CITY COUNCIL STAFF REPORT

Meeting: October 5, 2021

Consider an appeal of the Planning Commission's decision to uphold the Director of Community Development's approval of a Two-Story Permit to allow a new 2,992 square-foot two-story home with a 746 square-foot attached accessory dwelling unit and a Minor Residential Permit to allow a new 115 square-foot second-story balcony. (Application Nos.: R-2020-035, RM-2020-023; Applicant: Smart Lily, LLC.; Property Owners: Tariqul Khan and Chaman Hafiz; Appellants: Jitesh Vadhia and Chih-Lung Lin; Location: 1506 Primrose Way; APN # 366-15-018)

Figure 4. Revised front elevation

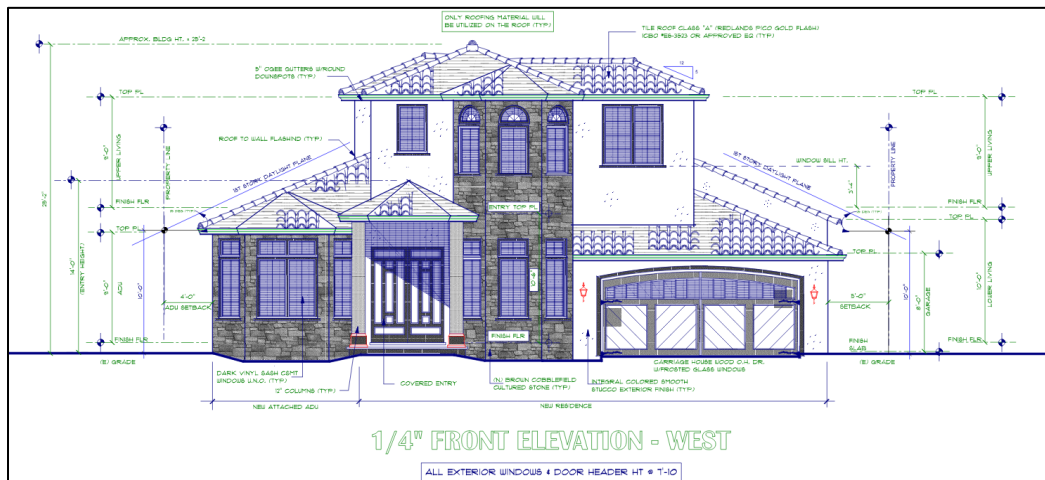
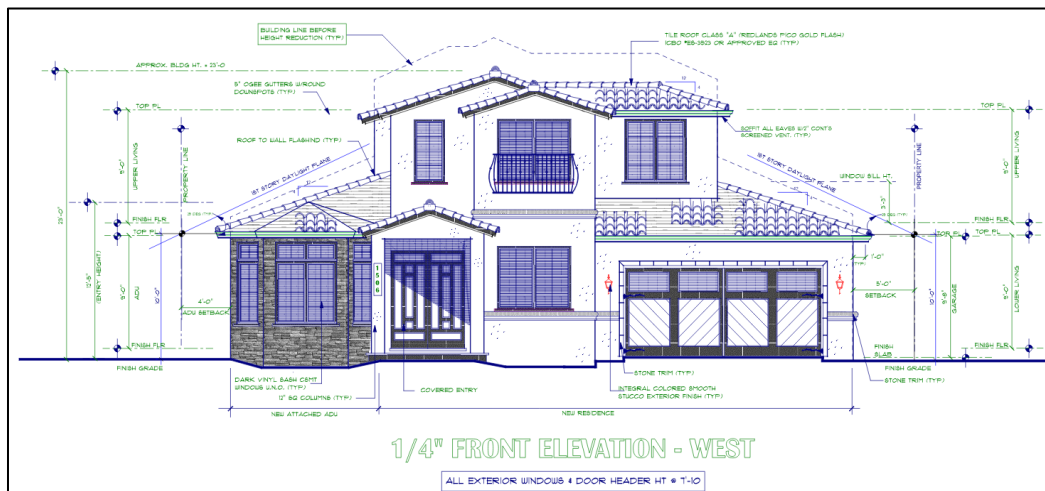
"Primrose Way is a community of beautiful single story homes. A two story construction will destroy the look and feel of the neighborhood. It's everyone's responsibility to uphold the integrity and feel of the neighborhood."

Staff conducted a review of the existing homes within a one-block radius along Primrose Way and Poppy Way and within a portion of the Monta Vista South neighborhood. Both reviews indicate that the surrounding neighborhood is transitional and comprised of a mixture of single-story and two-story residences. Within a one-block radius (*Figure 2*),

Following the public comment period, the project applicant reduced the proposed building height from 25'-2" to 23', where a maximum building height of 28' is allowed by the R-1 Ordinance. The Cupertino Municipal Code measures total building height from natural grade of the existing property but does not account for differences in grade between adjoining homes. The project, therefore, complies with the height limitations of the R-1 Ordinance. The proposal also meets, and in some cases exceeds, all setback requirements for the R1-6 zoning district. The project proposes a first-floor rear-yard setback of 28'-5", where only 20' is required; a second-story rear-yard setback of 34'-6", where 25' is required; and a rear-yard balcony setback of over 26'-6", where 20' is required.

Figure 5. Proposed privacy plantings shown in green

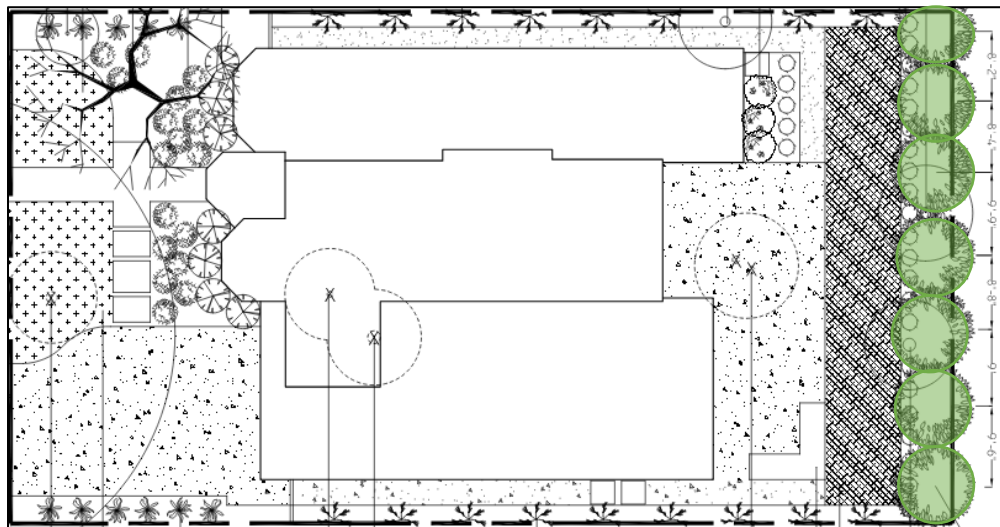
"The rear facing balcony continues to raise severe privacy concerns. The balcony has direct views into all my 1st and 2nd floor bedrooms and backyard. The height of the balcony, balcony wall height, and balcony side walls are detrimental to our privacy. The balcony should be removed."

"Privacy plantings along the utility easement will be inadequate. The height of the rear facing balcony requires very tall plantings. Those will take several years to grow. The planting[s] run along and below the utility easement significantly below the rear facing balcony height. This in combination with the several foot grade difference ensures my privacy is violated. The applicant has not addressed my privacy mitigation concerns."

The project complies with the privacy screening requirements of the R-1 Ordinance by providing privacy screening plantings for the second-story balcony as well as second-story windows with a sill height below 5-feet. The applicant has proposed to plant seven *Laurus nobilis* along the rear (eastern) property line to provide adequate screening for adjacent property owners (Figure 5). Privacy plantings for the right (southern) and left (northern) property lines are not required, as the applicant has obtained a signed privacy waiver form from the adjacent property owners at 1518 Primrose Way and 1492 Primrose Way.

Per the tract map and title report, the property has a 10-foot Public Service Easement (PSE) and a 5-foot Wire Clearance Easement (WCE) located at the rear of the property. The previously approved site plan inadvertently switched the locations of the PSE and WCE. This has been corrected with an updated site plan, which has been stamped as approved on September 23, 2021, and replaces the previously approved site plan. This has been incorporated into the approved plan set (Attachment F).

While the tract map indicates that development is regulated within the PSE and WCE, landscaping, including privacy plantings, is not restricted in the easement areas. Based on the revised site plan, the proposed *Laurus nobilis* will be located within the 10' PSE. An alternative to planting the trees in the PSE would be to locate the privacy trees outside the PSE and the WCE. While it would result in the trees being planted closer to the home and the balcony, it may be possible that fewer privacy trees would be needed to provide the same level of privacy.

Laurus nobilis is one of the City's approved privacy planting shrubs and shall have a minimum container size of 15-gallons and a minimum planting height of 6-feet. Mature height for *Laurus Nobilis* ranges from 15' to 40', with a mature spread of 20'. The finished floor of the second-story balcony is approximately 11'-4" above natural grade level. Per the R-1 Ordinance, the objective of privacy protection plantings is to provide substantial (not complete) screening within three years of planting to mitigate second-story window and balcony privacy impacts. Furthermore, privacy protection plantings are protected under the Protected Tree Ordinance, Chapter 14.18 of the CMC and are recorded as such with a covenant against the property to inform current and future property owners about their protected status. Protected trees are not permitted to be removed without obtaining a Tree Removal Permit and providing replacement plantings.
